Initial	Starting Line Number (e.g. 17)	Ending Line Number (e.g. 23)	Clause/Subclause (e.g. 3.1)	Type of comment <sup>1</sup>	Comments	Proposed change	Observation of the secretariat
<b>1</b>	KC2	1			Ge	The document title and organization title suggests that this PAS will apply in all countries worldwide	Please provide list of all countries for which this specification document is valid noting any exclusions.	NOT ACCEPTED - Countries who want to adapt it can
<b>2</b>	NP	1	Various places throughout document		Ge	The word " specification" is not appropriate here. As specification means "a detailed description of the design and materials used to make something." These test methods should be presented as guidelines. Does IWSFG intend to provide design parameters for flushable products?	Recommend changing the "specification" to "guideline" throughout all relevant documents.	NOT ACCEPTED
<b>3</b>	PG	1			Ge	Submitting comments on the IWSFG PAS documents in this public comment period in no way represents participation in the development process of the IWSFG PAS documents. Nor does commenting imply agreement with any content; where portions of the IWSFG documents have not been commented upon,

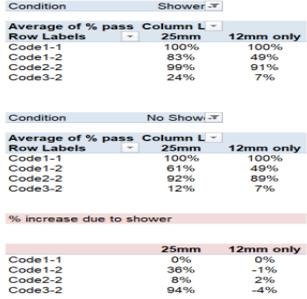
<b>52</b>	KC8c	108	112	2 Purpose	Te	There is no justification for the RPM change provided in the replies to version 1 public comments.		See Answer 40
<b>53</b>	KC8d	108	112	2 Purpose	Te	Reducing the time end point to 30 minutes and increasing the sieve size do not change the Reynolds number.		NOT ACCEPTED
<b>54</b>	KC9a	108	112	2 Purpose	Te	The Reynolds Number for this method is stated once again to be 20,000 yet the speed of the oscillation (between PAS3B and PAS3) has been increased by 23% - they cannot both provide Reynolds Number of 20000.		See Answer 40
